Service Bulletin

Product Family: 917001 27-Ton Log Splitter

Subject: Wedge Mounting Hardware Replacement

Dealer Action: Install New Mounting Bolts

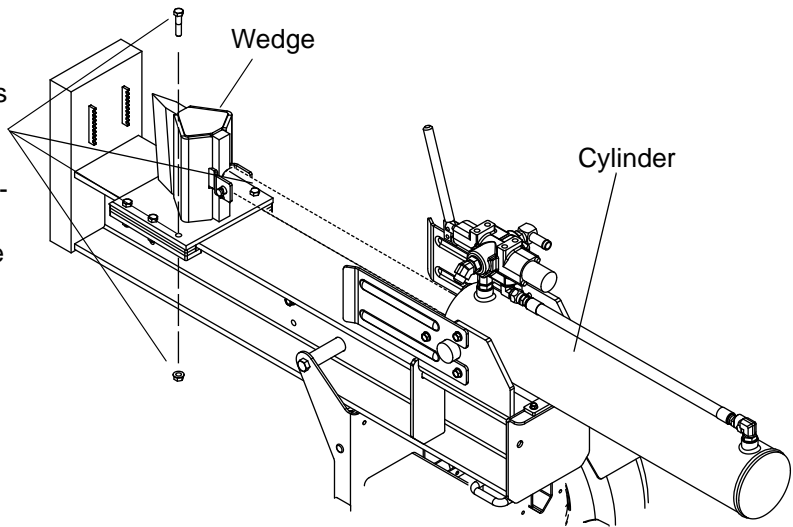
The Ariens Company has learned that the splitting wedge mounting bolts on the model 917001 27-Ton Log Splitter may fail under extreme loads. Replacing the two existing .38-16 hex bolts closest to the cylinder with two .50-13 x 2 Grade 8 hex bolts (p/n 05970700), two .563 x 1.38 x .109 flat steel washers (p/n 06442000), and two .50-13 center lock nuts (p/n 06536300) reduces the potential for failure under such loads.

Remove and discard the two 3/8 bolts and top locking flange nuts closest to the cylinder.

Use a 1/2" drill bit to bore out the mounting holes closest to the cylinder.

Install .50-13 x 2 Grade 8 hex bolt (p/n 05970700), .563 x 1.38 x .109 flat steel washer (p/n 06442000), and .50-13 center lock nut (p/n 06536300). Tighten to 50 lbf-ft (67.8 N•m).

.50-13 x 2 Grade 8 hex bolt (p/n 05970700)

.563 x 1.38 x .109 flat steel washer (p/n 06442000)

.50-13 center lock nut (p/n 06536300)
